California Vehicle Fill Pipe Specifications

Proposed Amendments

May 23, 2018

Proposed change: add performance standard

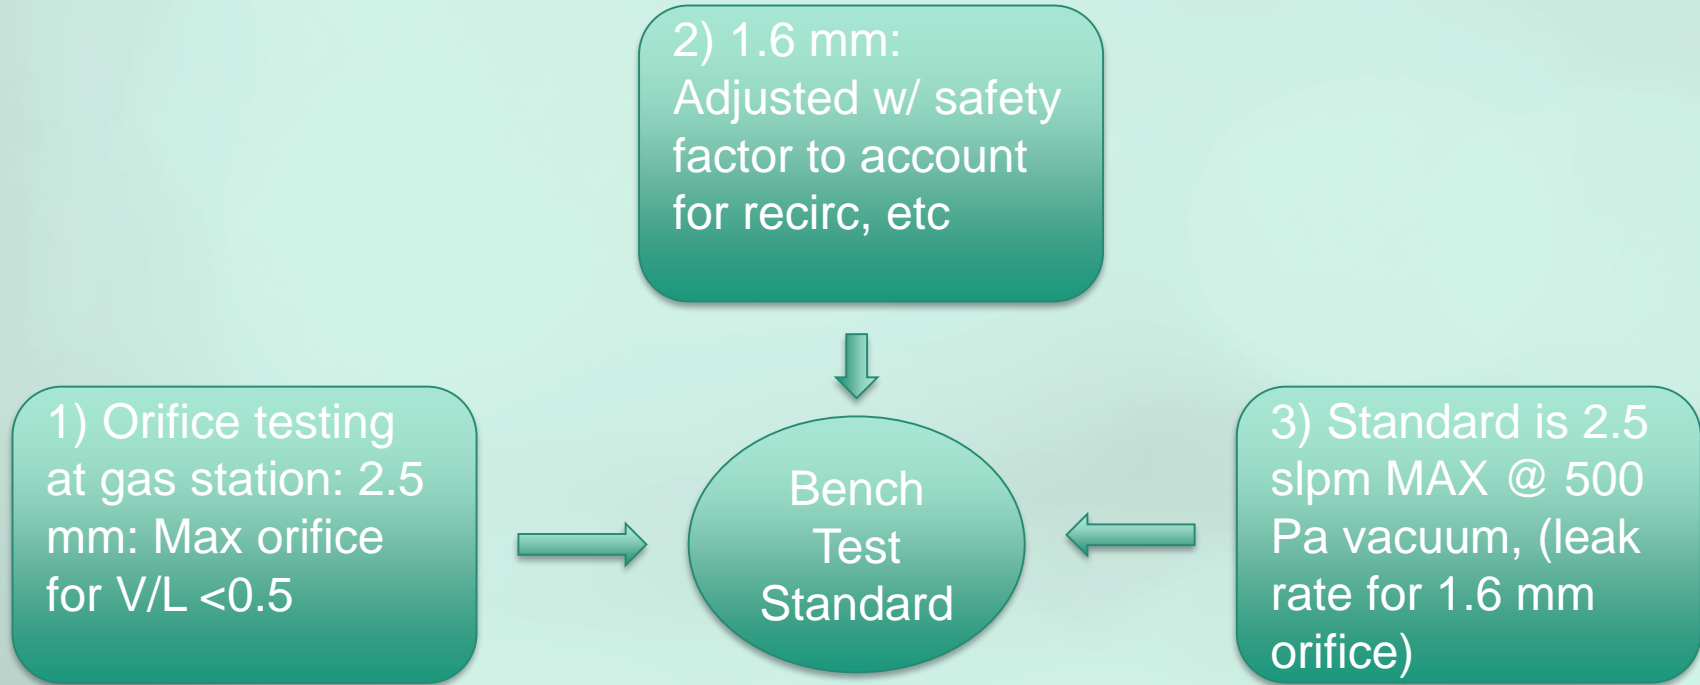
- Tests quality of nozzle seal to fill pipe (interface)
- Compliance method:
 - Bench test (surrogate to gas station testing)

- Removed V/L and Zero-leak Attestation options: since no industry interest

CARB's Bench Test Method + Equipment

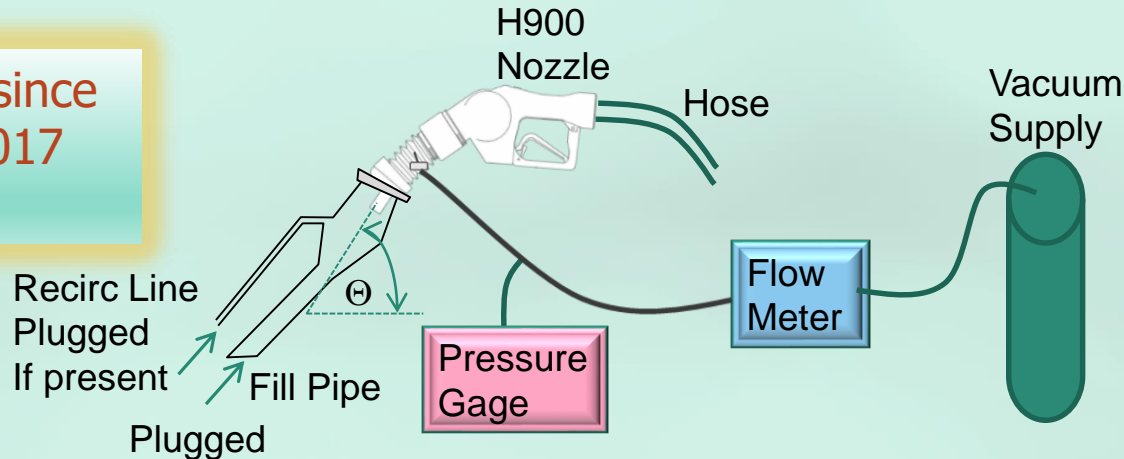
- Adjust vacuum supply: -500 Pascal @ pressure gage
- Output = leak rate in liters per minute @ flow meter
 - Compare with standard: 2.5 liters per minute

Access Zone Update: Why its needed

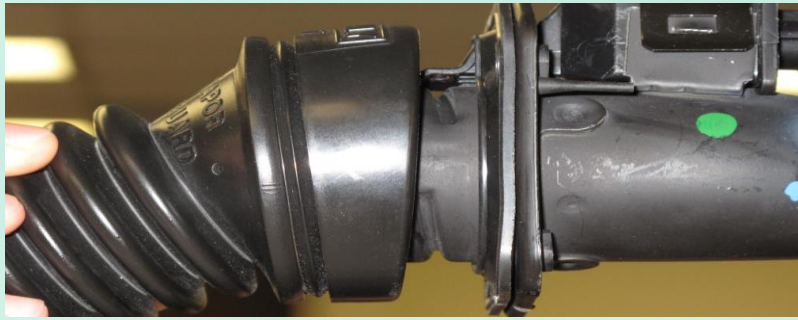
Boot overlaps fill pipe

Section V-V

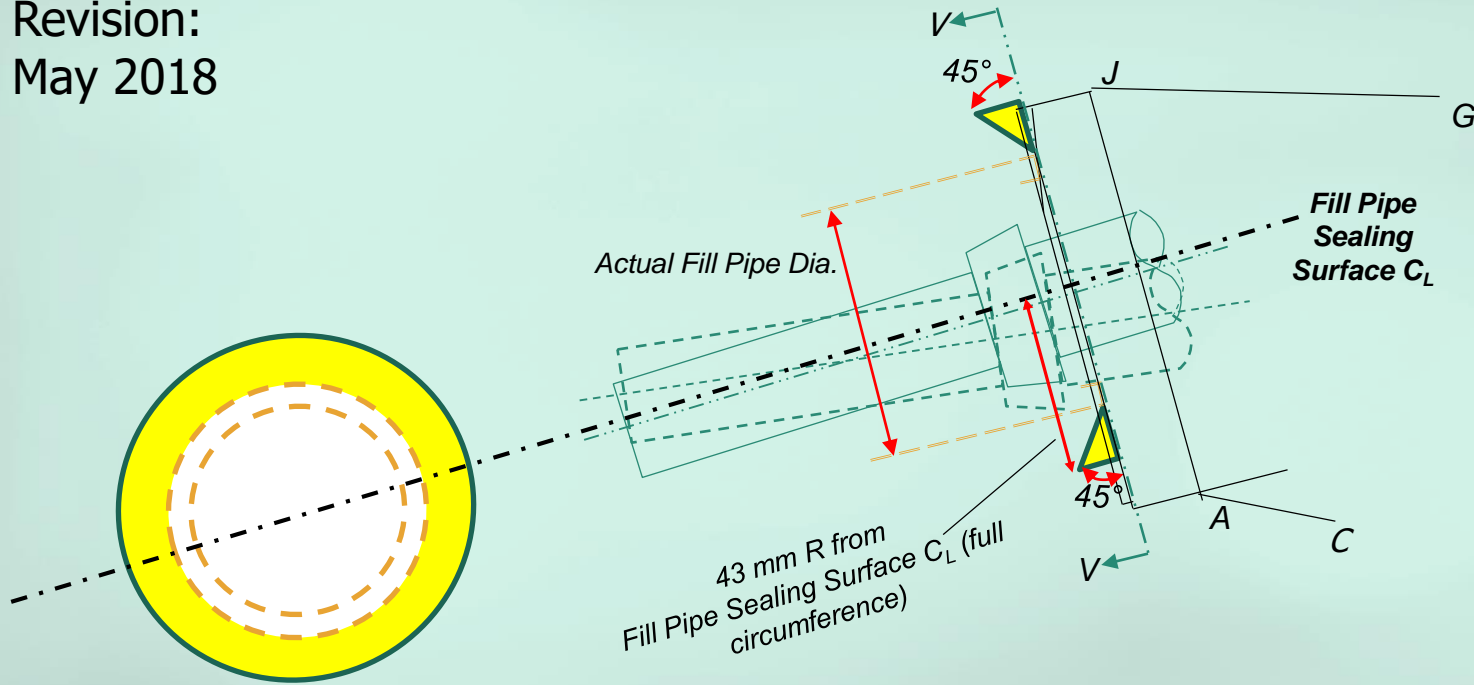
Changed
since
Dec 2017
workshop

Additional clearance to ISO 13331 access zone,
proposed by CARB

Locking Lip Depth Update

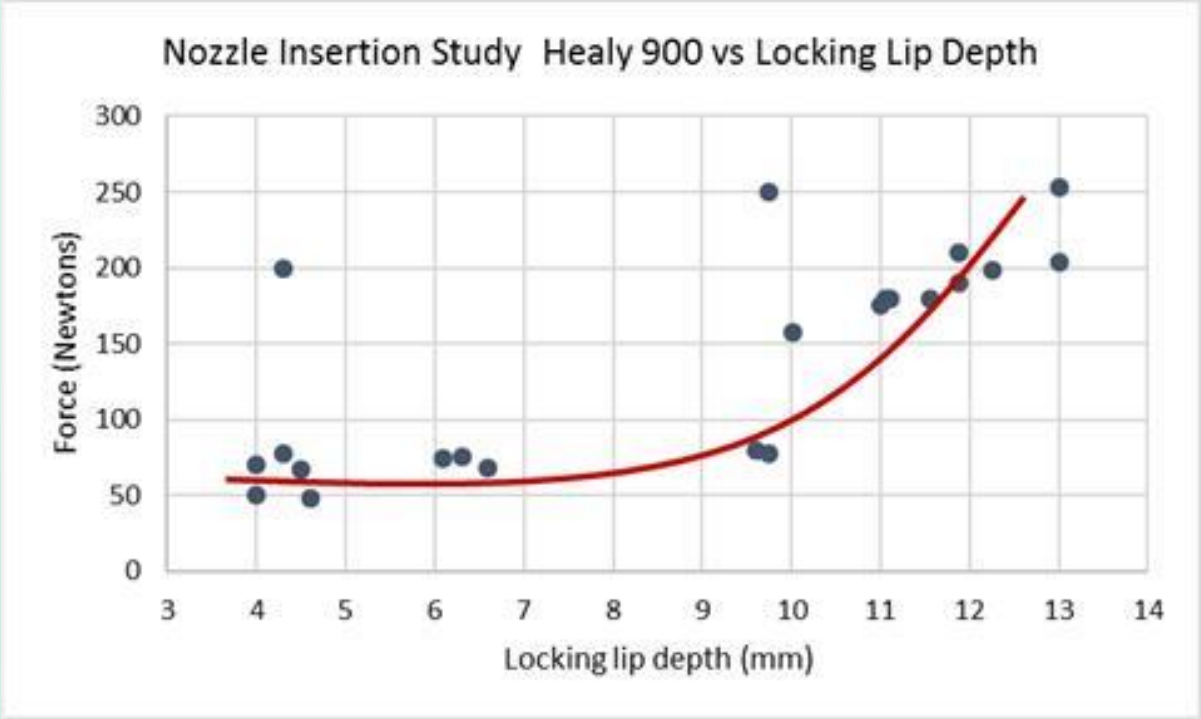
Goal: reduce “loose latching”

- Current: 4-13 mm
- Planned change: 4-10 mm
- Easier to latch nozzle
- Insertion force increases dramatically > 10 mm
- Source: SAE nozzle insertion study

Modify J1114's Alternate Shape

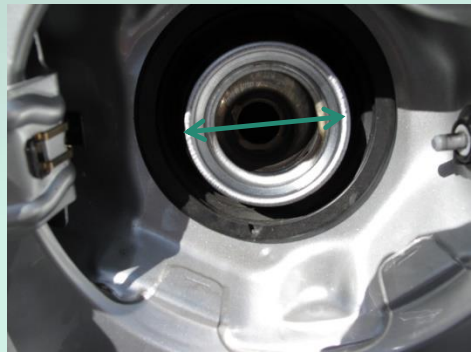
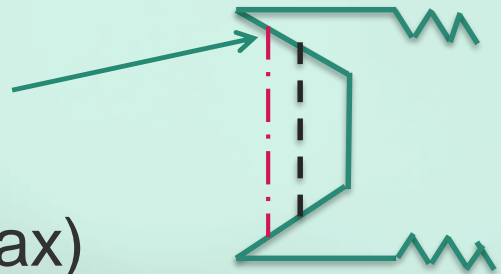
- Current Outer Diam. (OD) is too large (up to 61.6 mm)
- Results in about 1.7 mm of additional boot compression
 - Since contacts higher on conical boot
- Contributes to loose latching
- Proposal: Reduce OD to 57.9 mm (max)
 - Match with standard J1114
 - Very similar to ISO 13331
